**Town of Kittery
Planning Board Meeting
March 23, 2023**

ITEM 2 – 39 Badgers Island, Sketch Plan Review – Minor Cluster Subdivision

On behalf of BIW Group LLC – Owner and **Otter Creek Homes - Applicant** we submit herewith the attached package for **Final Subdivision Approval** at the March 23, 2023, Planning Board Meeting. In support thereof, we are submitting a revised Site Plan set with the associated revisions as needed to address the comments from CMA Engineers, along with this letter explaining the changes. The specific comments from the CMA letter are repeated below; with our response in **bold** text:

SHORELAND DEVELOPMENT PLAN C2

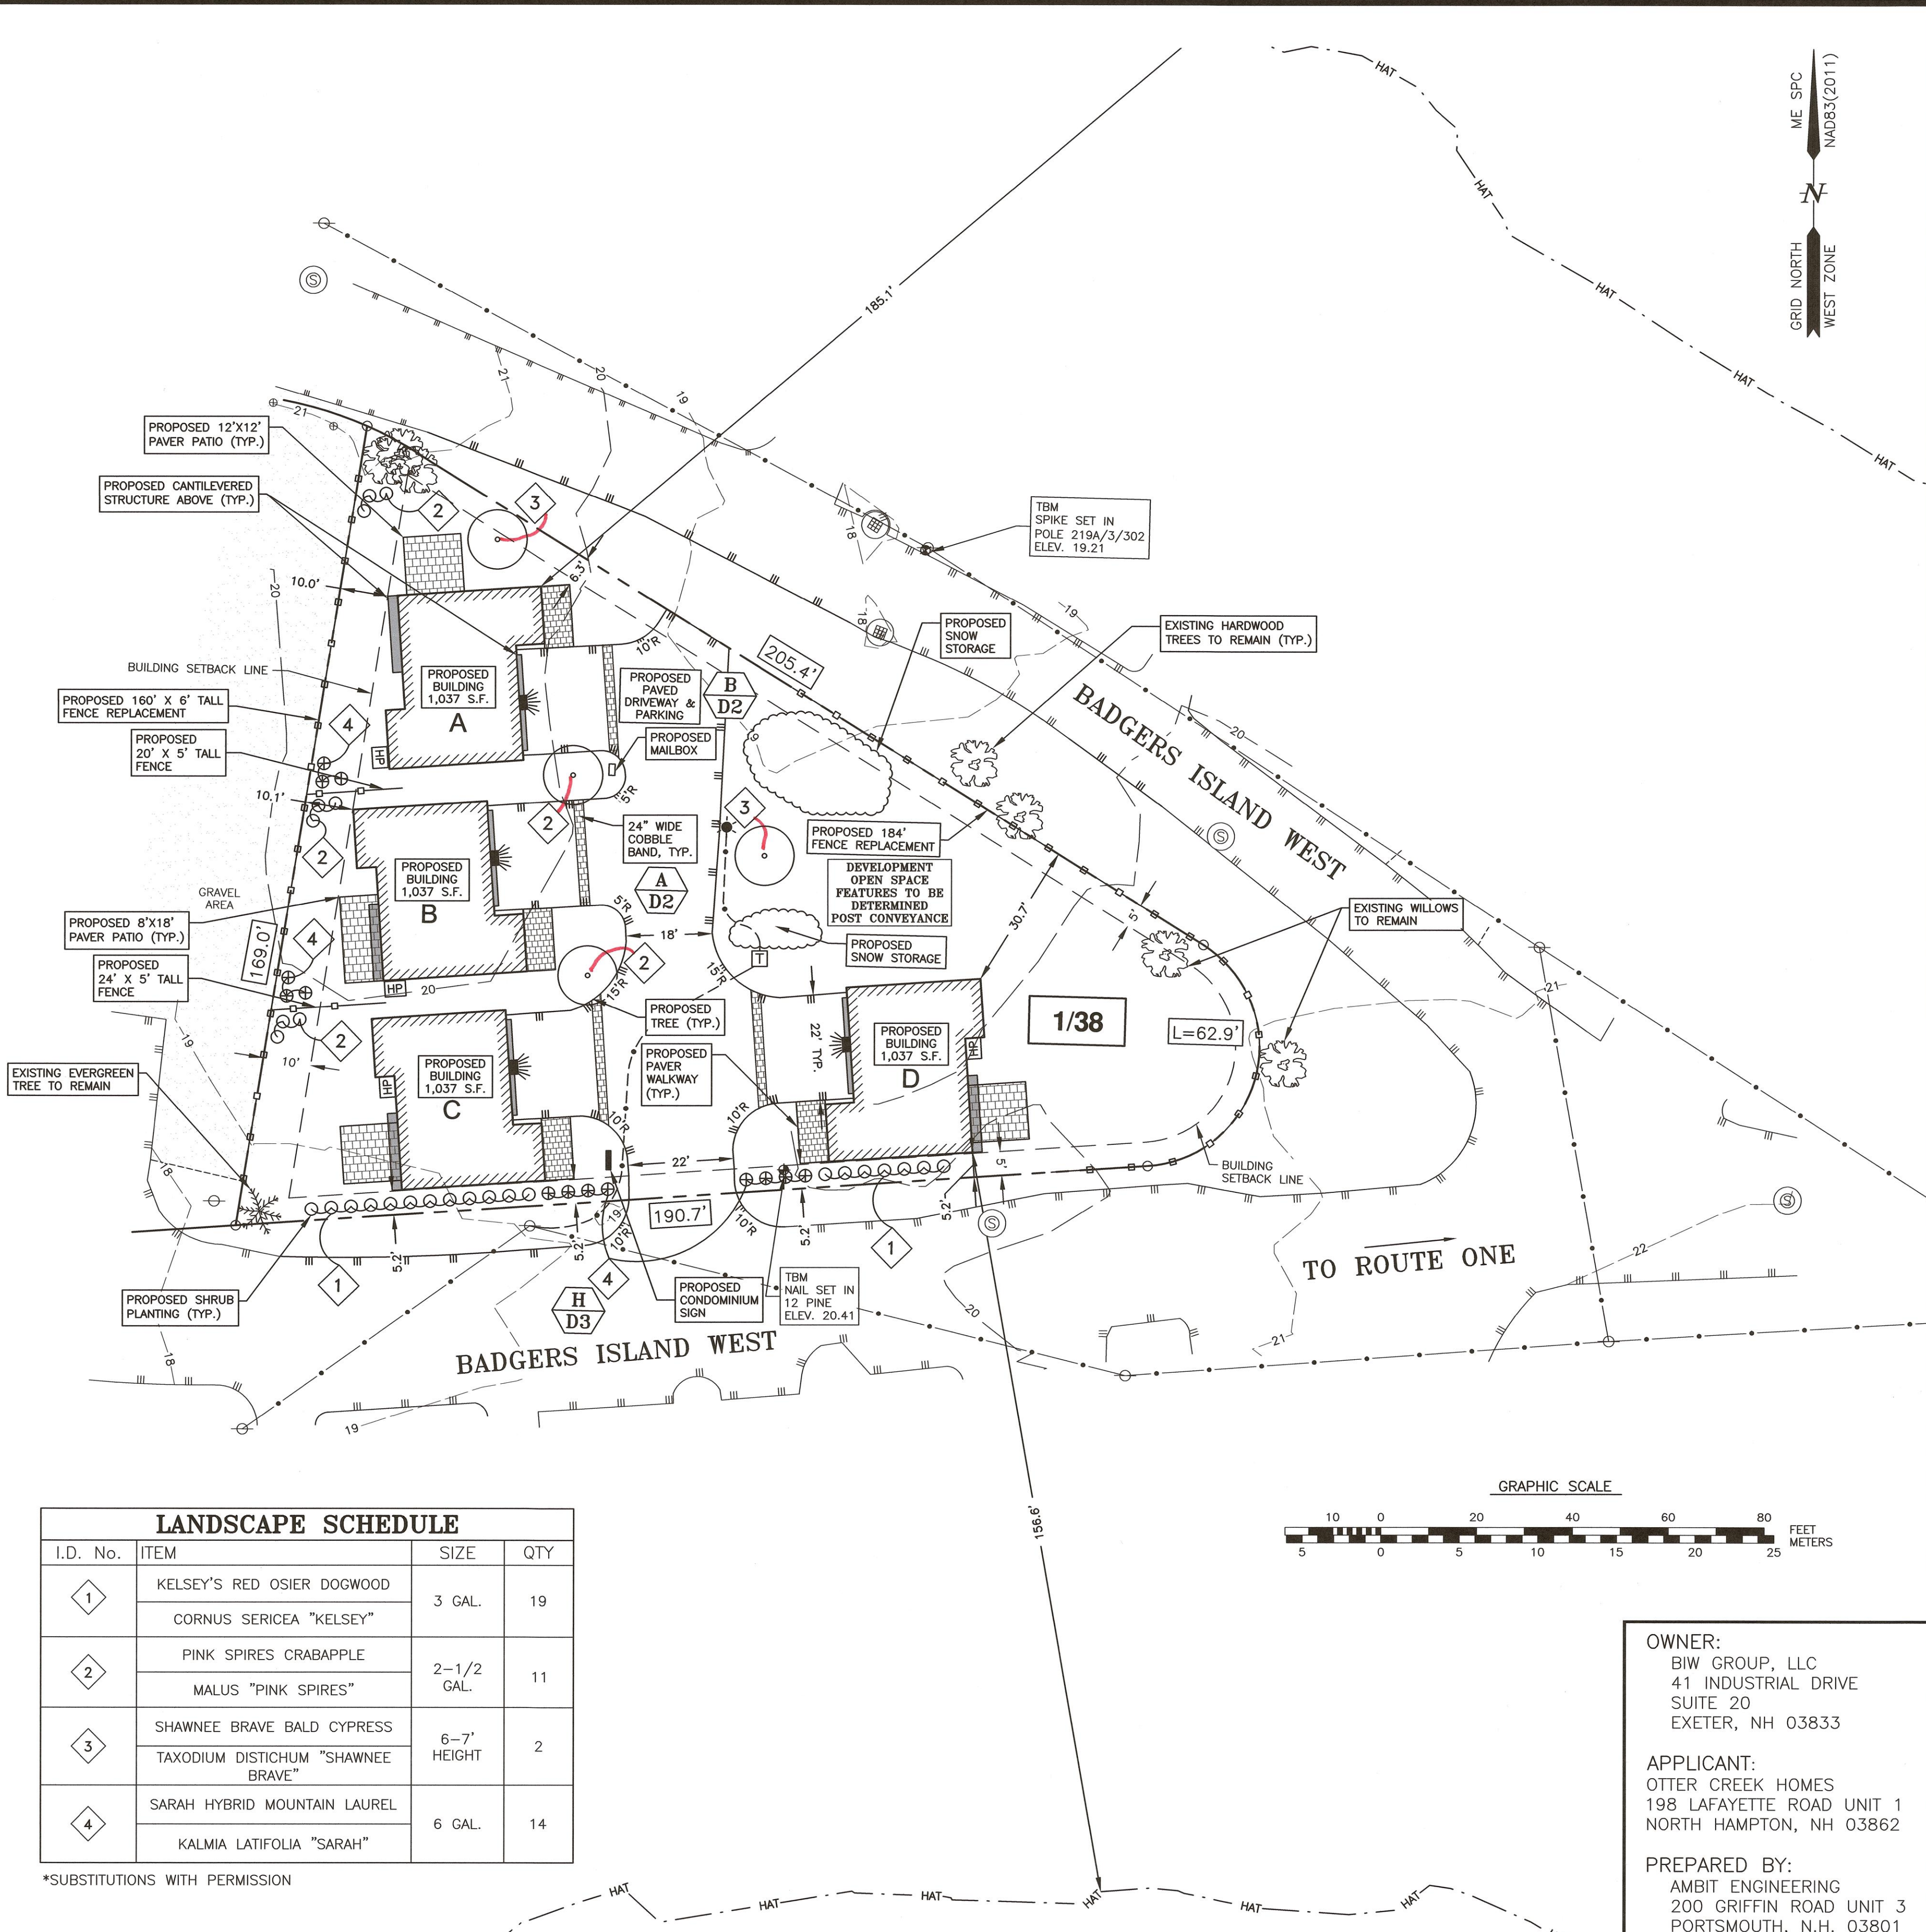
1. The landscape schedule quantities may not coincide with the number of species shown on the plan. **We reviewed the count; our plan is correct.**
2. The landscape species 1 and 4 have the same symbol and are not clearly labeled on the plan. These should be different symbols and clearly labeled. **We did adjust one of the symbols to be clearer. Each number designation is tied to the particular plant(s).**
3. “Conveyence” is spelled incorrectly. **Completed.**
4. There is a TBM to the southwest of proposed building D that is “set in 12 pine) but no pine is shown. **This tree will be removed; we turned off the TBM note.**
5. The tree to the northwest of the site should be labeled as “to remain”. **We labelled the trees to remain once (each tree type) with a TYP label.**

GRADING PLAN

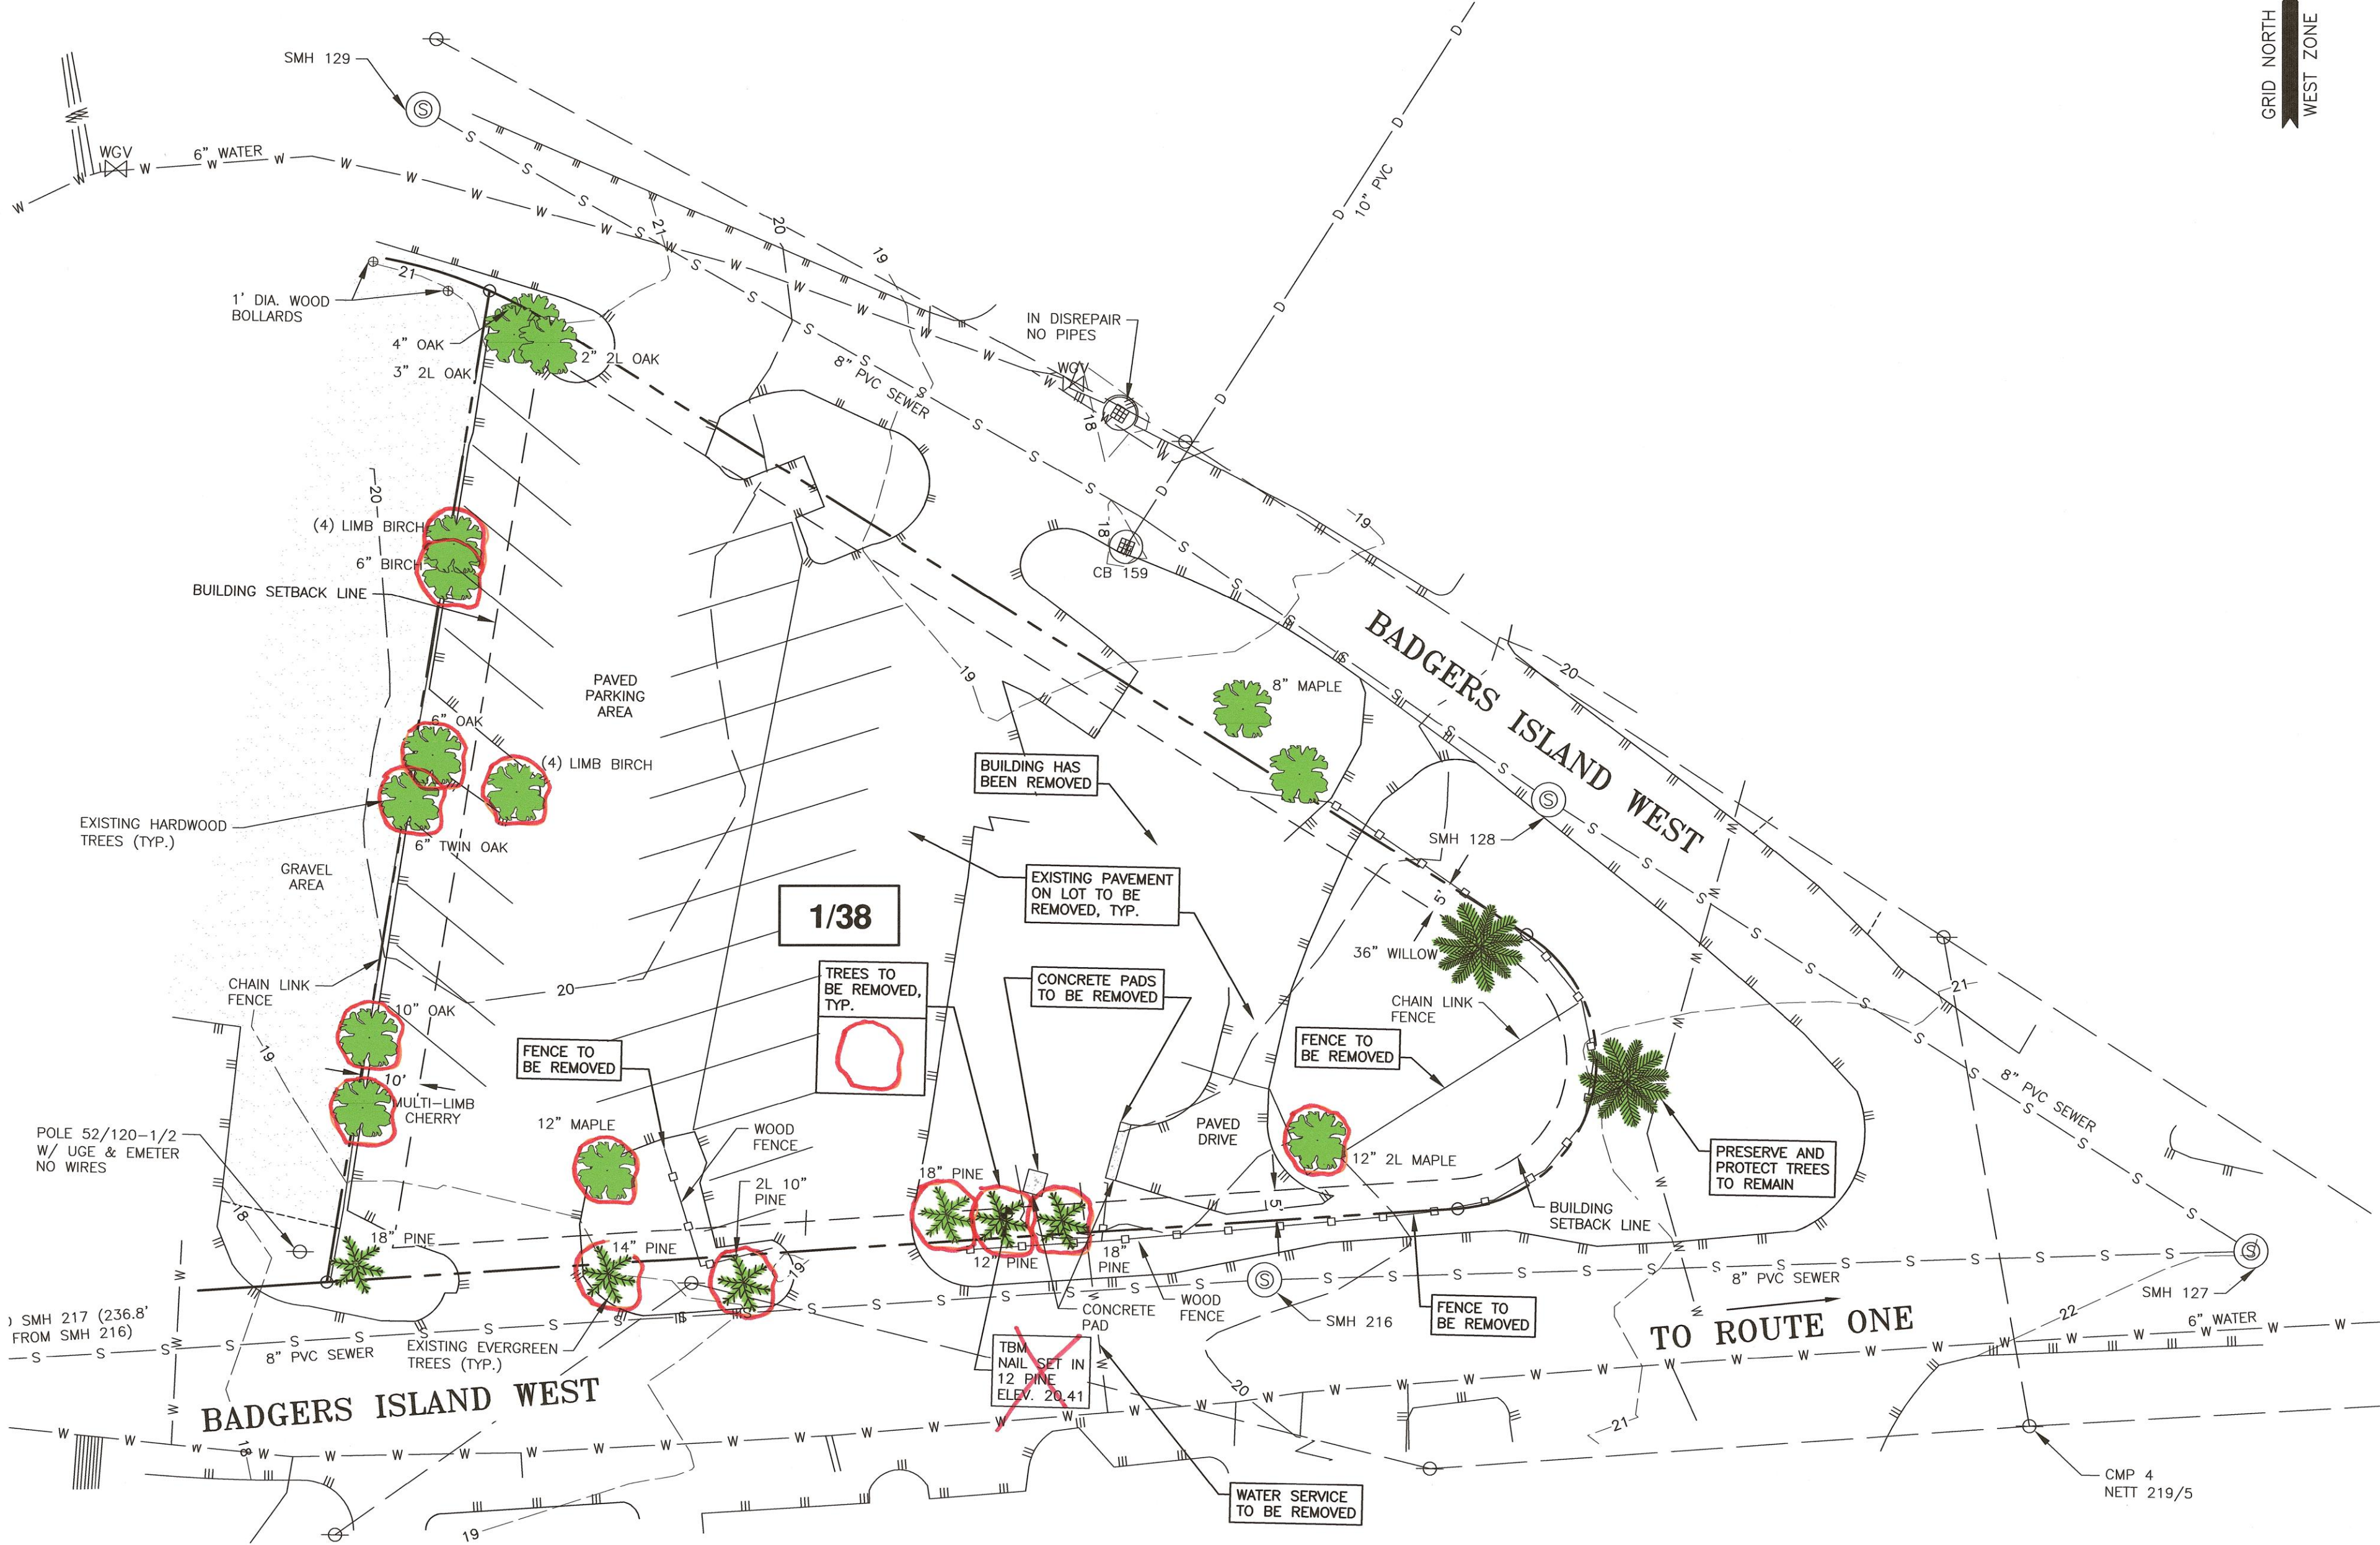
1. The limits of the construction entrance should be shown on the plan. **Completed.**
